NPF-10/15-449

CURRENT TECHNICAL SPECIFICATION IMPROVEMENT PROGRAM
(PCN 299) TECHNICAL SPECIFICATIONS

REVISED TECHNICAL SPECIFICATION IMPROVEMENT PROGRAM
(PCN 299) TECHNICAL SPECIFICATIONS

REVISED TECHNICAL SPECIFICATION IMPROVEMENT PROGRAM
(PCN 299) TECHNICAL SPECIFICATIONS

FIGURE 3.7.18-1

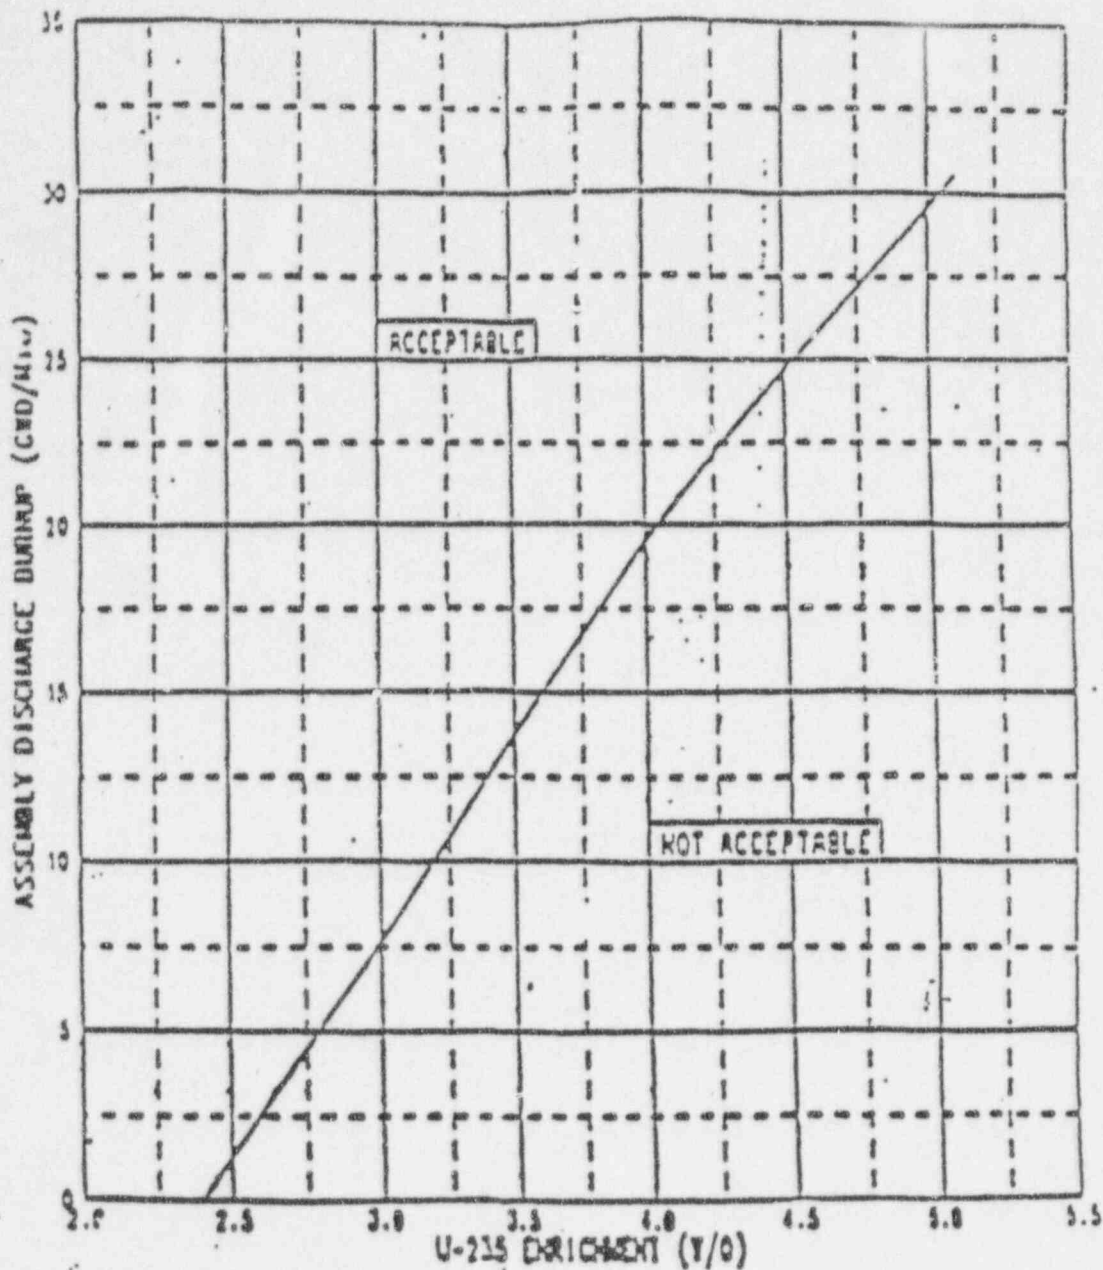
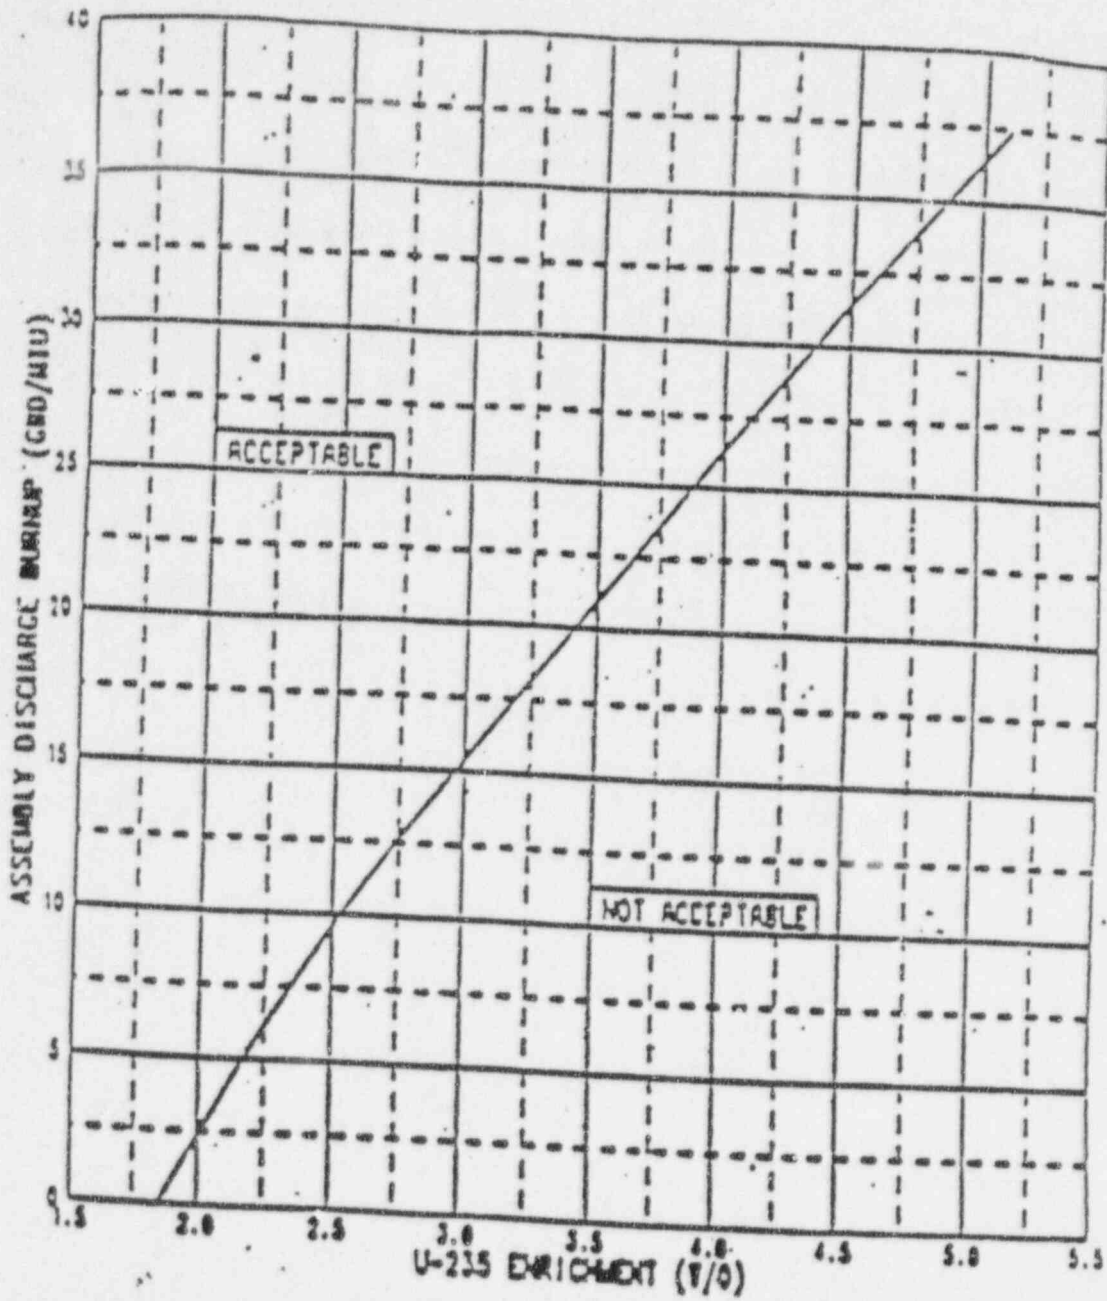
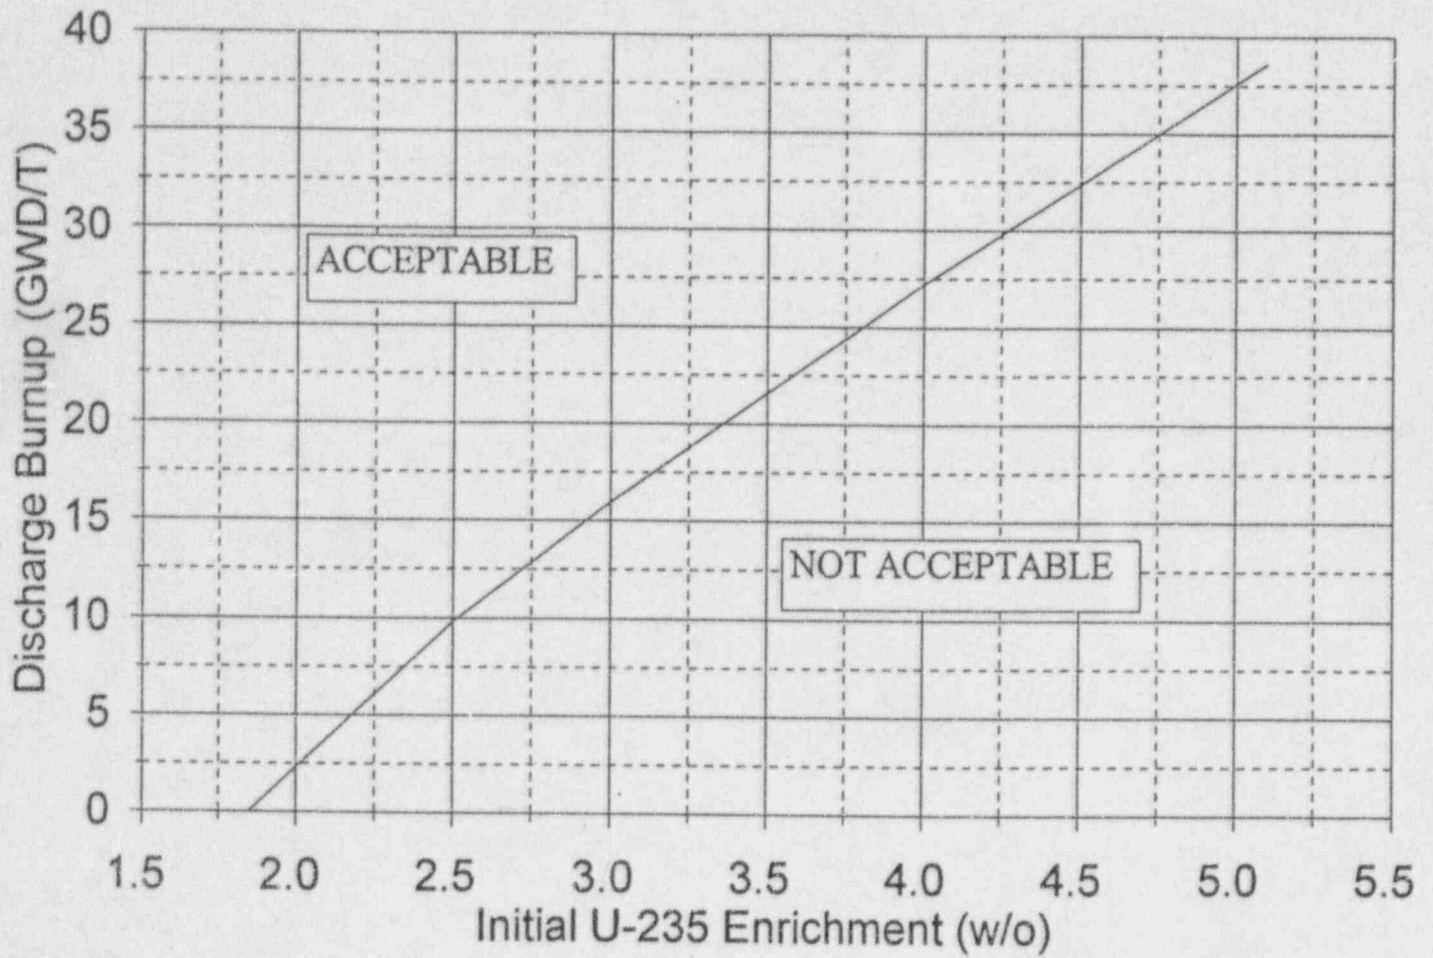
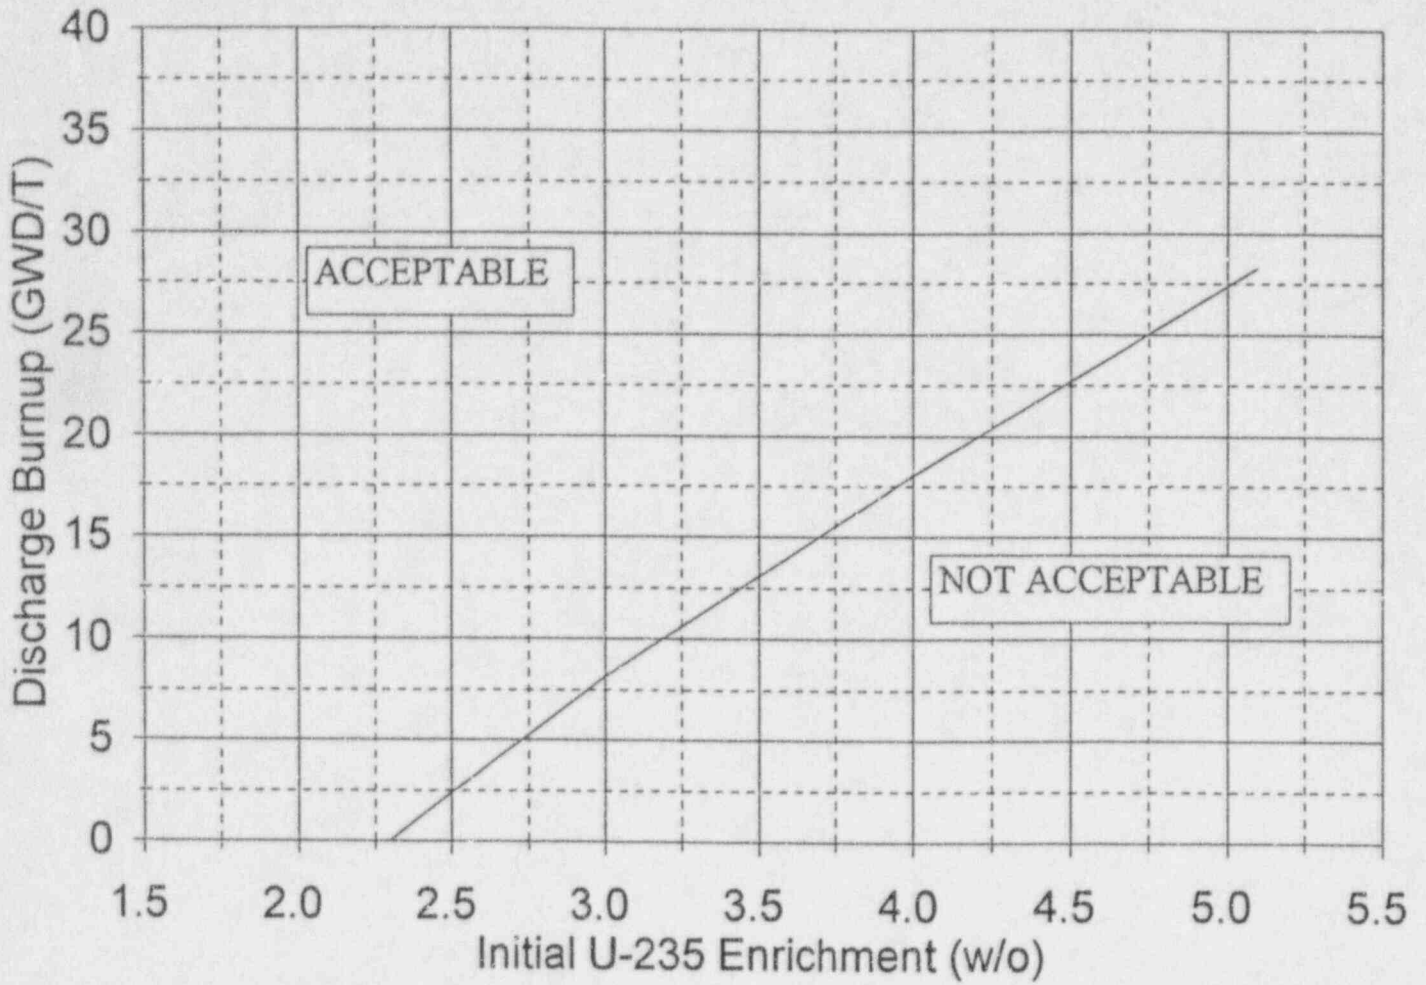
LCO 3.7.18 The combination of initial enrichment and burnup of each SONGS 2 and 3 spent fuel assembly stored in Region II shall be within the acceptable burnup domain of Figure 3.7.18-1 and or Figure 3.7.18-2, or the fuel assembly shall be stored in accordance with Licensee Controlled Specification 4.3.1.1 4.0.100.

- e. Units 1, 2, and 3 Fuel assemblies may be stored in Region I with no restrictions;
 - f. Units 2 and 3 Fuel assemblies with a burnup in the "acceptable range" of Figure 3.7.18-1 and ~~Figure 3.7.18-2~~ are allowed unrestricted storage in Region II; and

MINIMUM BURNUP VS INITIAL ENRICHMENT FOR UNRESTRICTED
PLACEMENT OF SONGS 2 AND 3 FUEL IN REGION II RACKS

- g. Units 2 and 3 fuel assemblies with a burnup in the "acceptable range" of Figure 3.7.18-2 are allowed unrestricted storage in the peripheral pool locations with 1 or 2 faces toward the spent fuel pool walls of Region II;

- h. Fuel assemblies with a burnup in the "unacceptable range" of Figure 3.7.18-1 or ~~and~~ Figure 3.7.18-2 will be stored in compliance with ~~the~~ Licensee Controlled Specification 4.0.100; and

MINIMUM BURNUP VS INITIAL ENRICHMENT FOR PLACEMENT
OF SONGS 2 AND 3 FUEL IN REGION II PERIPHERAL POOL LOCATIONS
